ADDENDUM NO. 2

November 7, 2022

CENTRAL HIGH SCHOOL HVAC IMPROVEMENTS

This Addendum forms a part of and modifies the Bidding Requirements, Contract Forms, Contract Conditions, the Specifications, and the Drawings dated October 3, 2022, by TowerPinkster. Acknowledge receipt of the Addendum in the space provided on the Bid Form. Failure to do so may subject the Bidder to disqualification.

SHEET NUMBER
A 102D2
21-806.00

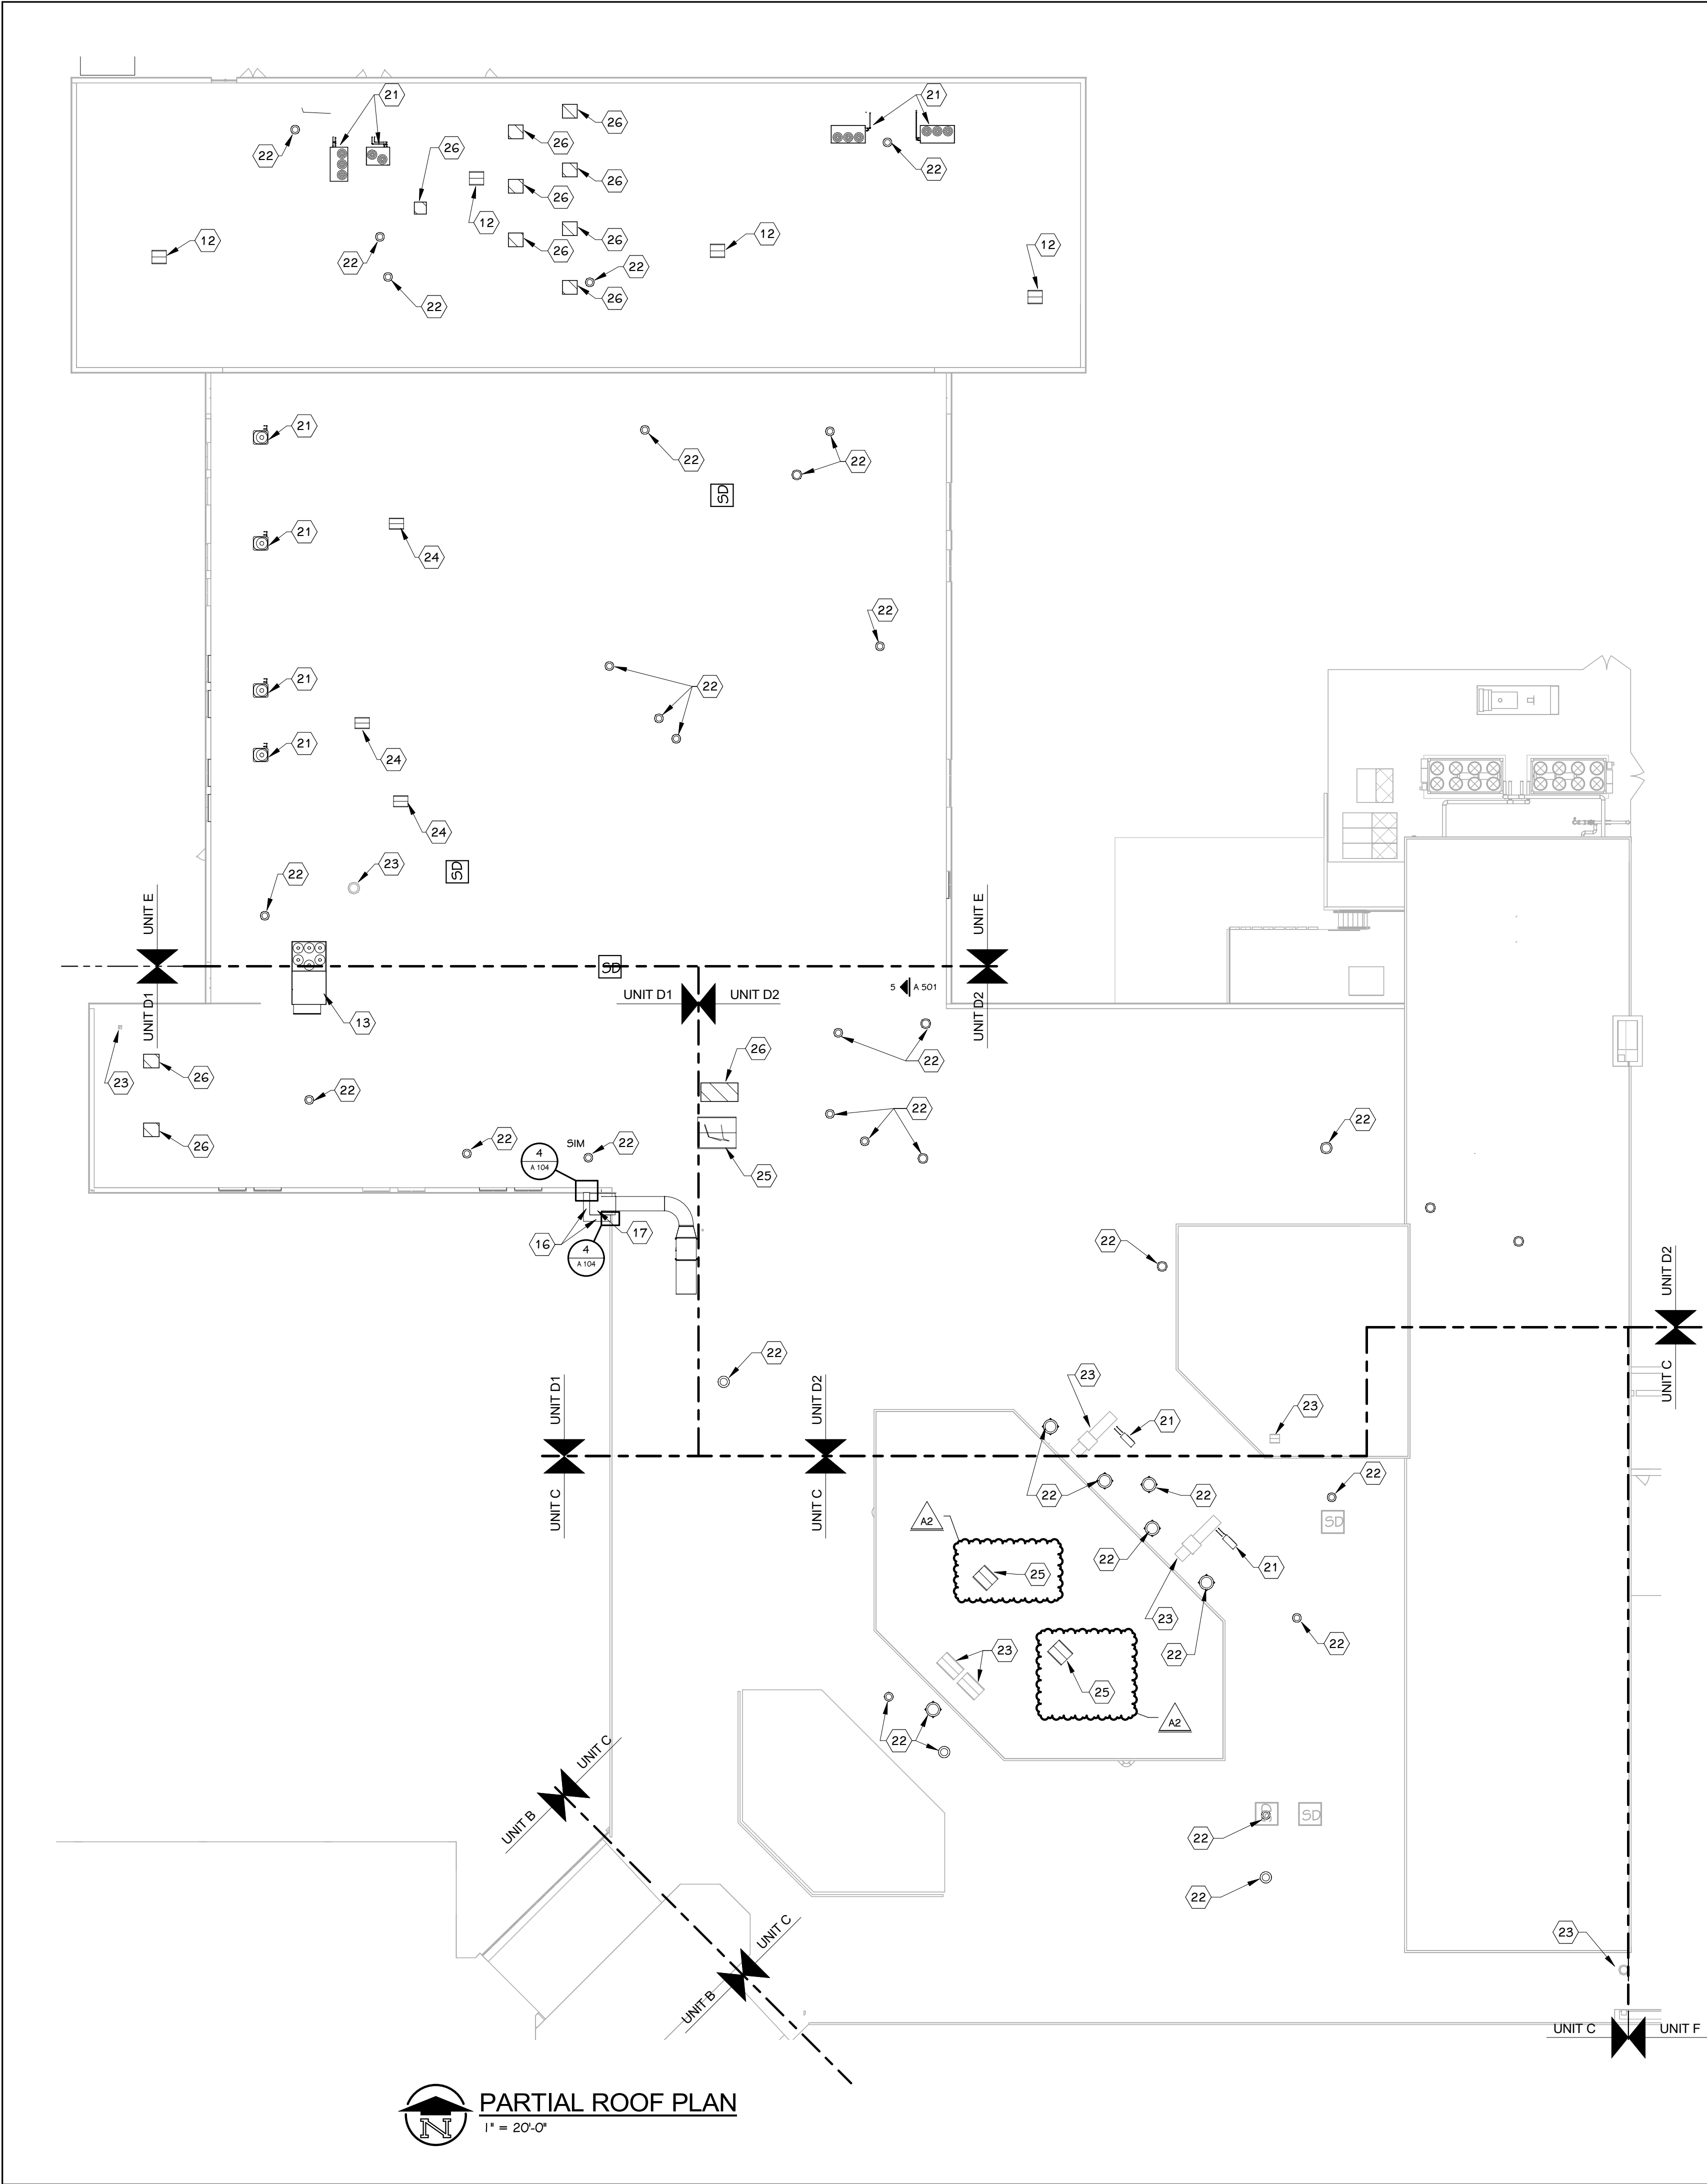
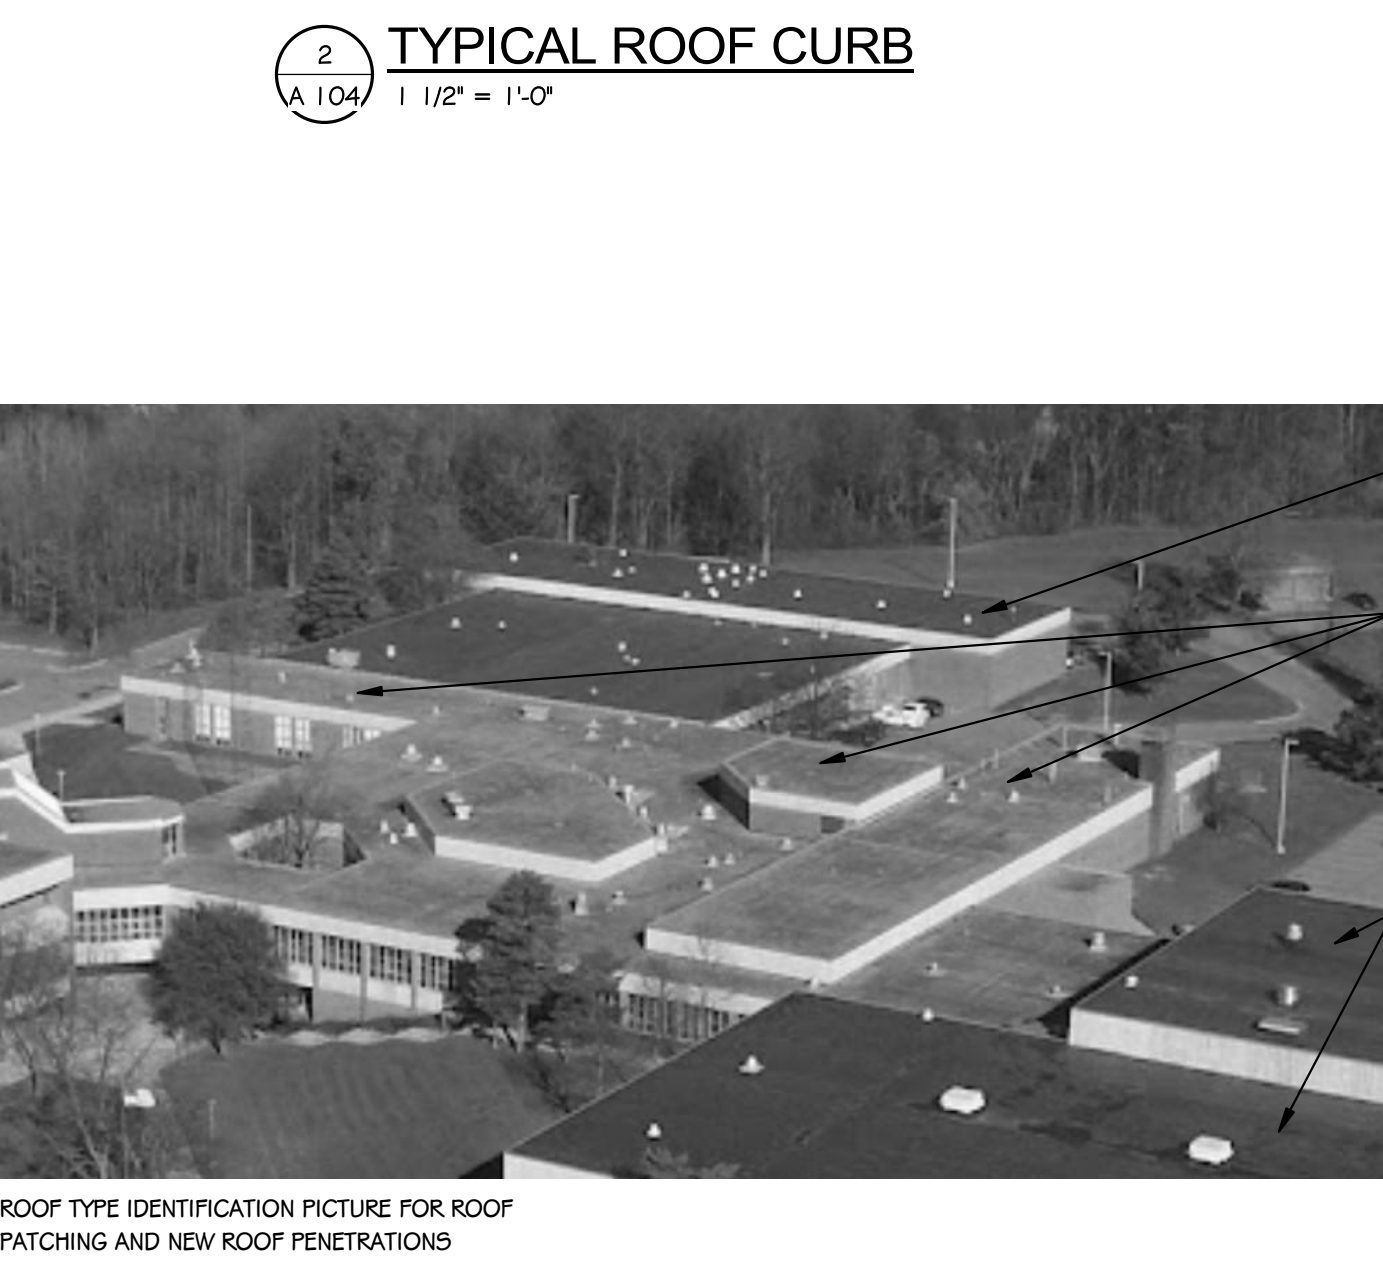
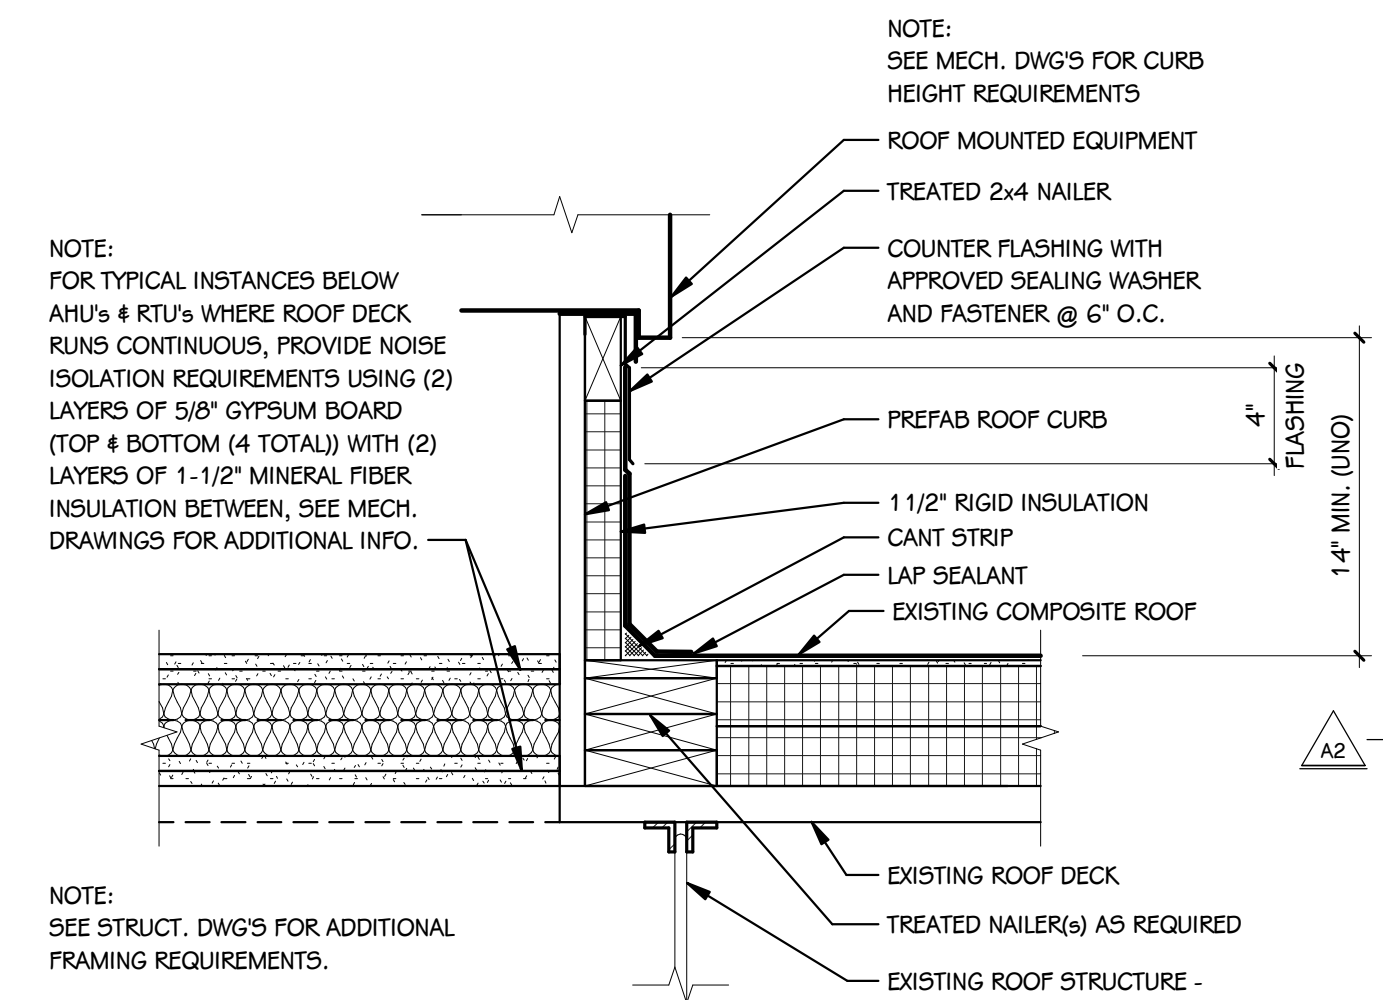
ADD-2 Item No. D-8 - Added Multiple Pipe Routings Through Walls

Added multiple face shell removal and reinstallation of new. Tooth-in, prime and paint to match existing.
